**Commonwealth Edison**

Subject: Braidwood Unit 2  
Environmental Qualification  
Bunker Ramo Penetration  
NRC Docket No. 50-457

BRAIDWOOD UNIT 2 ENVIRONMENTAL QUALIFICATION EVALUATION  
FOR THE BUNKER RAMO INSTRUMENTATION PENETRATION ASSEMBLIES

### SUPPLEMENT TO APPENDIX B

# Midland II Tested Configurations Versus Braidwood Unit 2 Installed Configuration

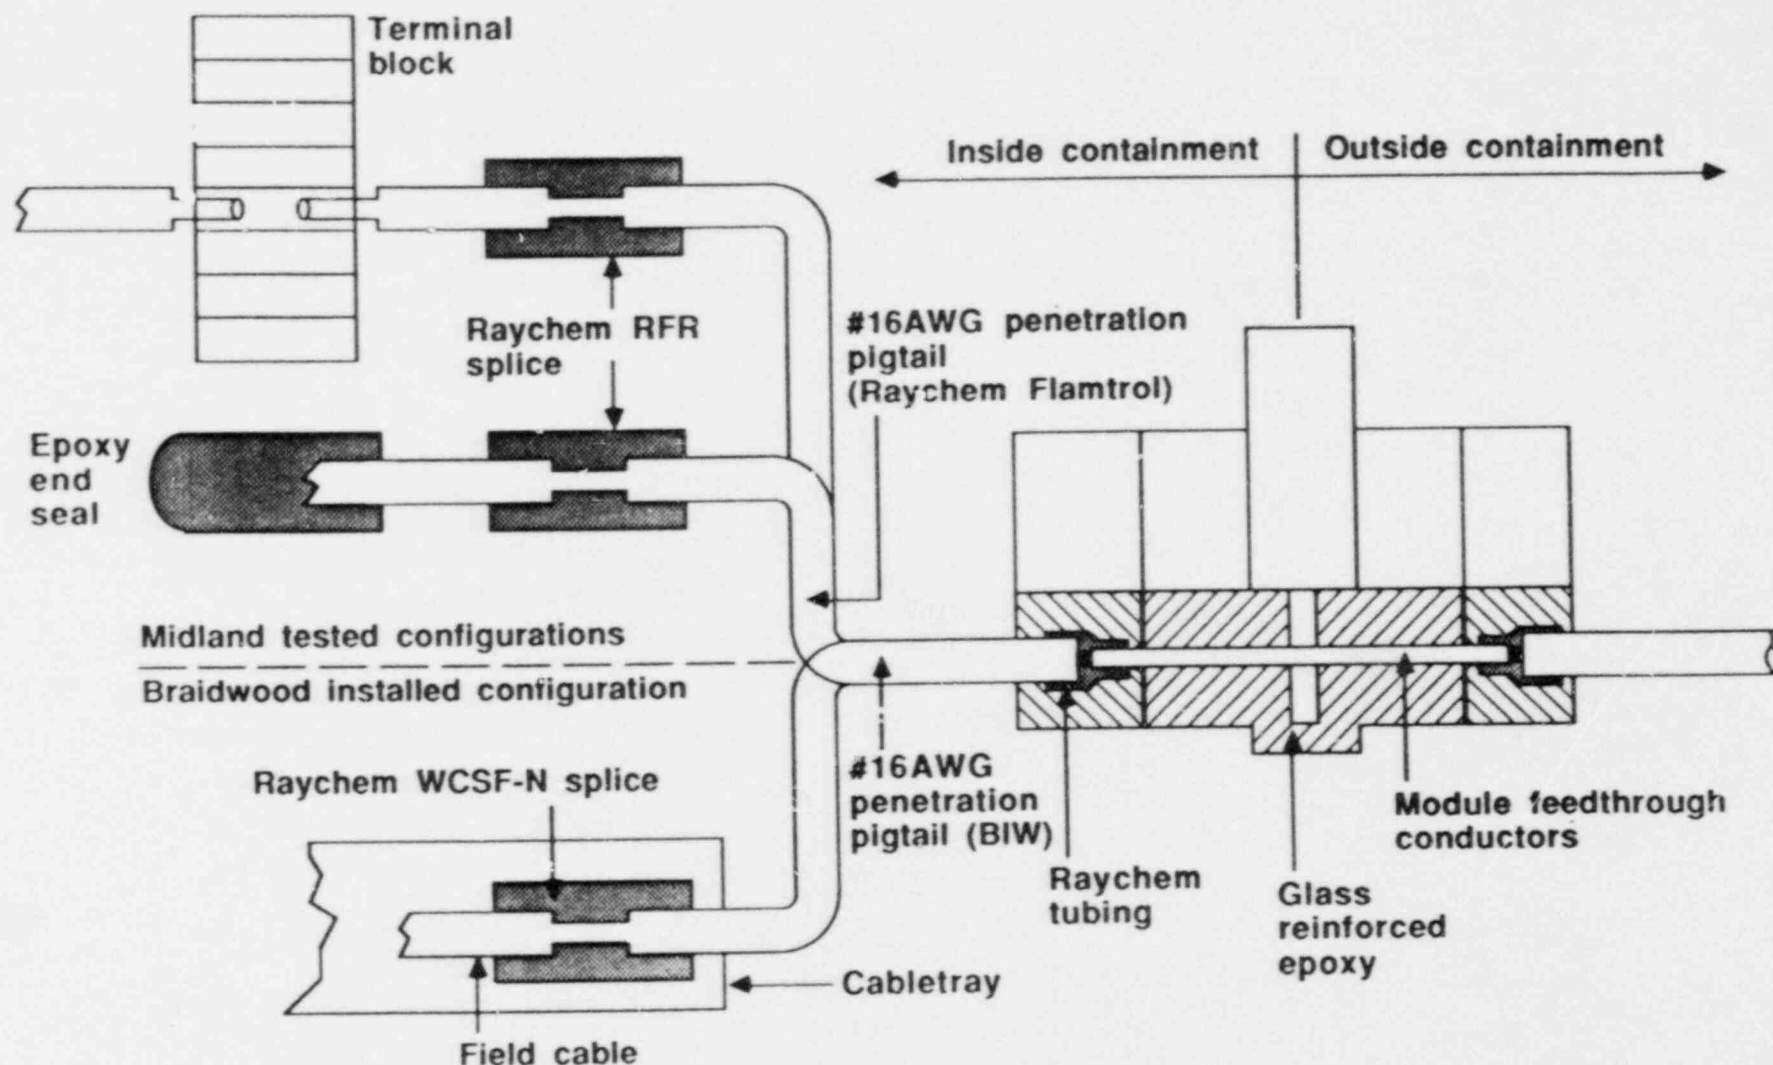
Exhibit 1 shows the Midland 2 tested configurations (terminal blocks and Raychem splices) and the Braidwood Unit 2 installed configuration. The Midland 2 configuration with the Raychem splices and the Braidwood Unit 2 configuration are quite similar with two differences:

- a) Midland 2 pigtail material is Raychem flamtrol while Braidwood Unit 2 is Boston Insulated Wire (BIW). However, both materials are qualified for this application.
- b) The Midland 2 RFR Raychem splices do not provide an environmentally sealed connection. The Braidwood Unit 2 WCFS-N Raychem splices do provide an environmentally sealed connection.

# Midland II Test Configurations and LOCA IR Values From the Test Log

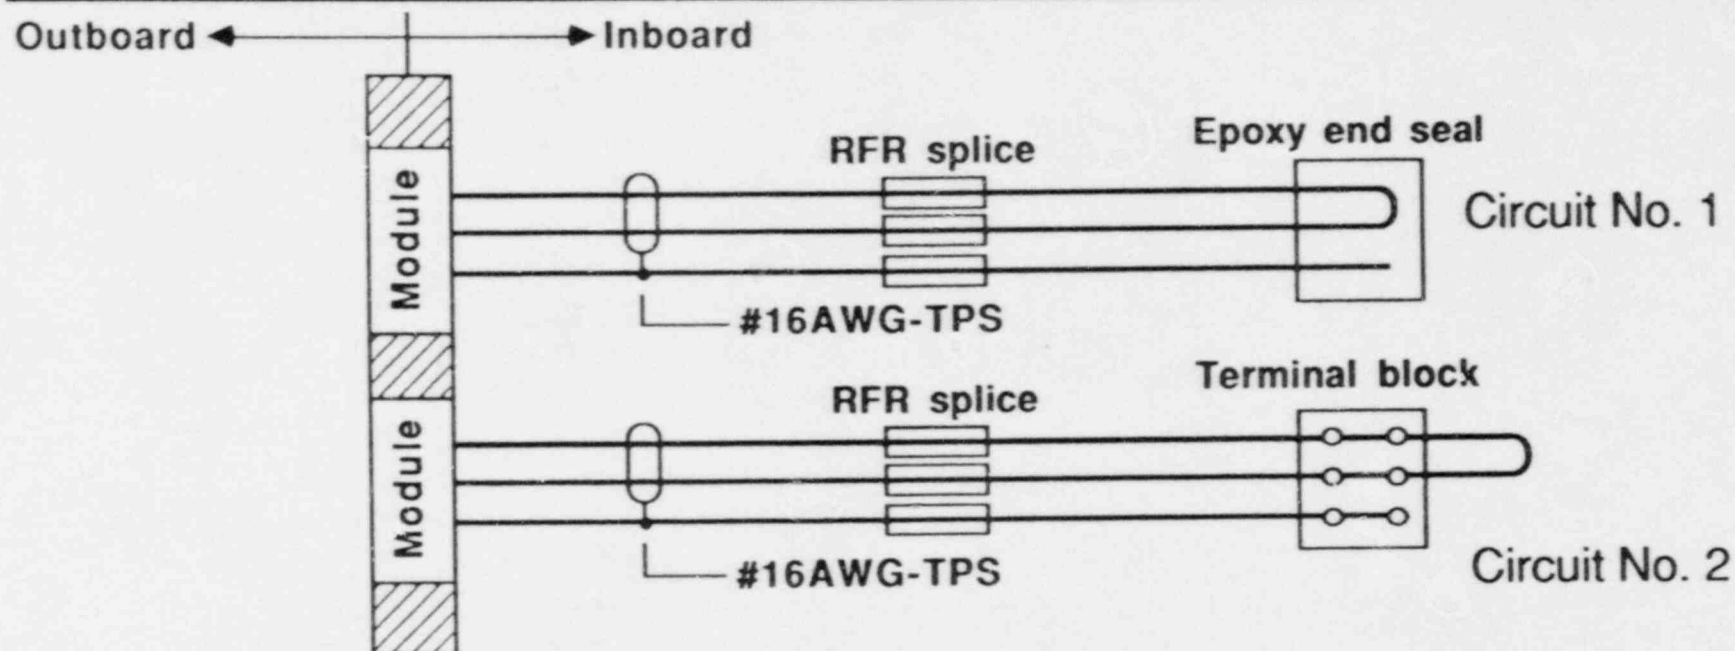
Exhibit 5 shows the measured IR values for both terminal blocks and Epoxy End Seal configurations. This data is reported through a letter from ANCO Engineers, dated March 11, 1988. The configuration utilizing terminal blocks has much lower IR values which supports our previous conclusions.

The Midland II test results presented in Appendix B indicate that the minimum Insulation Resistance (IR) recorded during the LOCA, for the #16 AWG instrumentation circuits utilizing the Raychem RFR splices and Epoxy End Seal, was  $1.0 \times 10^6$  Ohms. This IR value was measured "eight hours into the LOCA" (Reference Page 14 of the Midland II Test Report 123-2201). Based on the Midland II Test Report LOCA profile, eight hours into the LOCA corresponds to 180°F. However, the Braidwood Unit 2 peak LOCA temperature is 320°F. Therefore, what assurance is there that the recorded IR value of  $1.0 \times 10^6$  Ohms represents the lowest value that may be encountered since it was not measured at the peak temperature of the LOCA profile?

- A. Subsequent to the March 16, 1988 Washington meeting, ANCO Engineers Inc., provided correspondence (dated March 21, 1988) that demonstrated when and at what temperature the Midland II instrumentation penetration assemblies IR values were measured. ANCO Engineers, Inc., indicated a review was conducted of the temperature strip chart records for the Midland II penetration LOCA test. ANCO concludes from their review of the strip charts and the log book, that the initial IR readings were taken between 3:12 and 7:00 a.m., October 25, 1978. ANCO states that during this time the temperature in the test chamber ranged between 200°F and 250°F. ANCO documented that the second IR reading was taken at 10:00 a.m. on October 27, 1978. At this time the temperature in the test chamber was between 200°F and 250°F. ANCO further states that during October 25 and 27, 1978, the temperature was above 200°F except for four very short periods (less than 5 minutes) where the temperature dropped to 175°F-220°F.

The ANCO information as provided in their March 21, 1988 letter is the basis for our use of 200°F as the minimum temperature for the measured Midland IR value of  $10^6$  Ohms. Section B below documents the use of the Bunker Ramo penetration assemblies based on the information from the Midland test. Section C below independently documents the qualification of the Bunker Ramo penetration assemblies via an analysis of the Braidwood test report data.

Based on the above, it should be concluded that the IR value of  $1.0 \times 10^6$  Ohms measured during the Midland II LOCA test at 200°F represents the minimum IR value that may be encountered at the Braidwood Unit 2 penetrations. This conclusion is conservative because (a) the maximum temperature at the installed Braidwood Unit

2 penetrations has been calculated to be under the 200°F that was measured in the Midland II test (i.e. a higher IR value should be expected at the lower calculated temperatures at Braidwood Unit 2) and (b) the installed penetrations include environmentally sealed connections while the Midland II test specimens did not.

# Braidwood Unit 2 Bunker-Ramo Penetration Heat Transfer Model

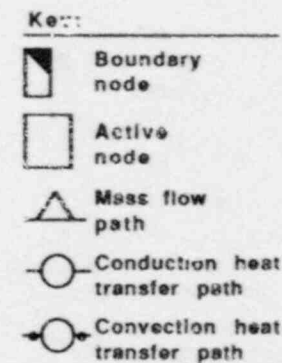
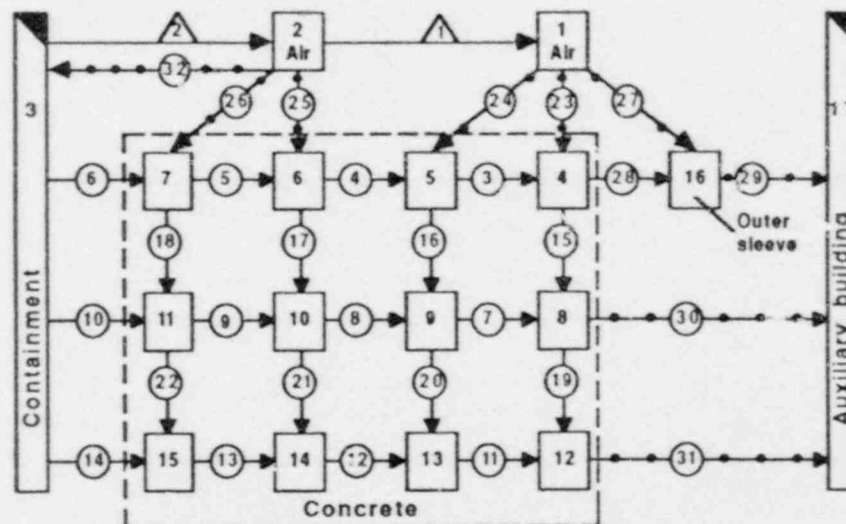
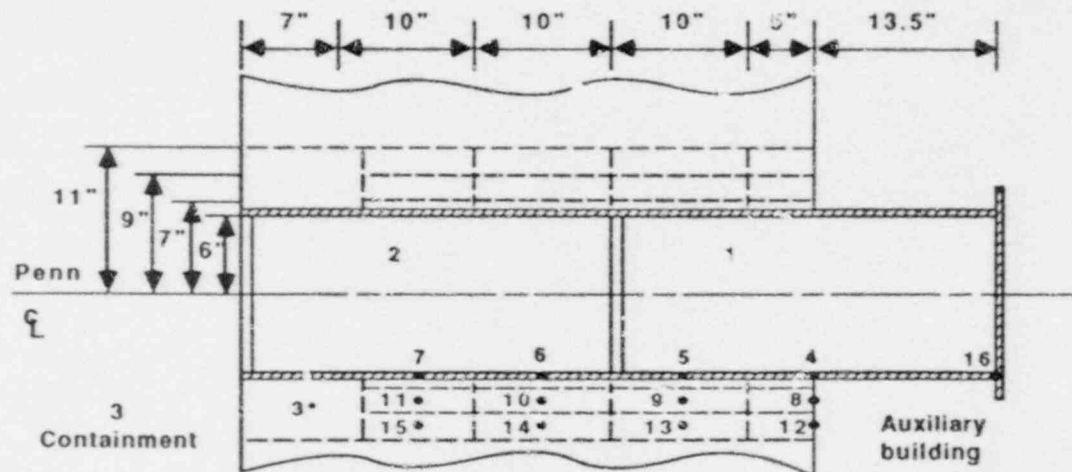
To evaluate the effect of the accident temperature pressure transient on the feed through module, a computer model of the containment and the penetration was prepared. The first node in the model was the area between the center support plate and the closure flange of the penetration. The feed through module is partially exposed to the environment in this node. The second node in the model was the portion of the penetration assembly between the inboard support plate and the center support plate. The third node in this model was the containment volume. The nodes communicate with each other by means of the openings in the support plates. The model also accounts for heat transfer into the surrounding steel and concrete and into the Auxiliary Building Electrical Penetration area. A diagram of the model is given in Exhibit B-1.

# Braidwood Unit 2 Bunker-Ramo Penetration Short-Term Heatup Curve

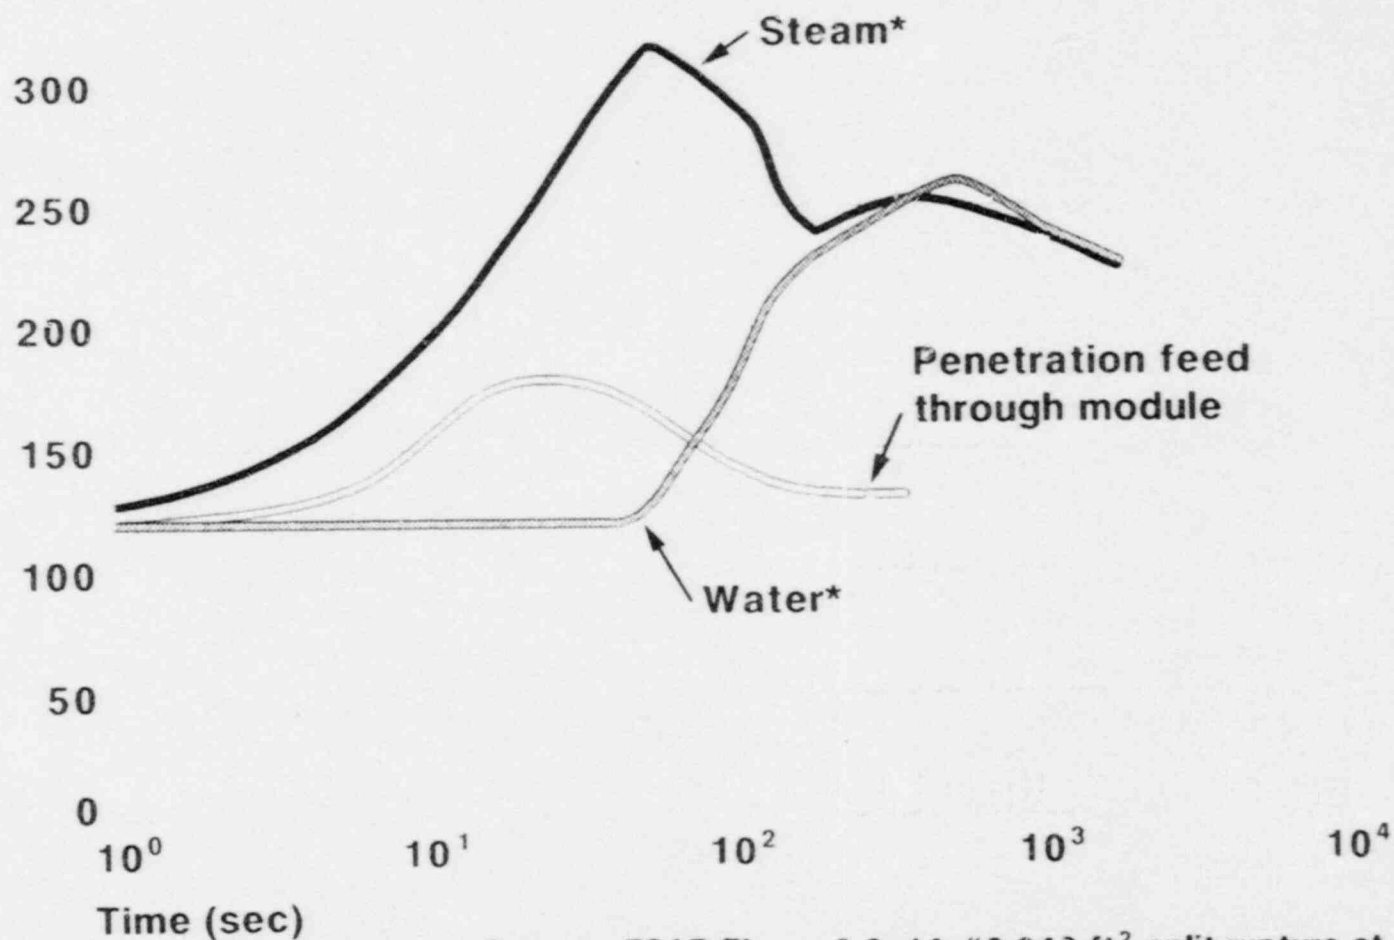
This computer analysis utilized the Westinghouse mass-energy release data and the containment pressure - temperature curves from FSAR Chapter 6 to establish the time dependent conditions in Node 3. Using this input, the time history of the pressure/temperature conditions in Nodes 1 and 2 was calculated. Exhibit B-2 shows the temperature on Node 1 (adjacent to the feed through module) plotted on the containment temperature curve for the Main Steam Line Break (FSAR Figure 6.2-14). It should be noted that the maximum temperature at the feed through module prior to trip initiation (10 seconds) is  $151^{\circ}\text{F}$ . This temperature is well below the temperature at which the Midland IR value was measured of  $200^{\circ}\text{F}$ . Because the temperature at the Braidwood penetration feed through module will never exceed the  $200^{\circ}\text{F}$  value at which the Midland IR test data was taken, the MSLB computer analysis is considered binding for the Main Feedwater Line Break, also. This is based on FSAR Section 6.2.1.4.

Finally, an evaluation of the long term penetration temperature was made. As can be seen from Exhibit B-2, the model predicted that the penetration would return to less than 130°F after approximately 400 seconds. A steady state evaluation is being performed using the longer term conditions to demonstrate that no significant heatup due to convective mixing between the vapors in the penetration and the vapors in the containment was expected in the long term. This evaluation envelops the long term LOCA and MSLB environments. No significant heatup of the penetration due to convection is expected.

In summary, calculations were performed that demonstrate that the temperature rise at the Braidwood feed through modules during the initiation of the MSLB, will not exceed the 200°F temperature where the Midland IR data was collected. This calculation envelops the LOCA and FWLB and demonstrates the actuation of reactor trip and safety injection prior to achieving an excessive temperature. An additional evaluation is being performed to confirm that a long term heat up of the penetration is not expected in the post-accident mode that would potentially affect the post accident monitoring instrumentation. The purpose of this evaluation is to provide further support for the use of the Midland penetration qualification data. The completed evaluation will be summarized and available for NRC review on Monday, March 28, 1988.
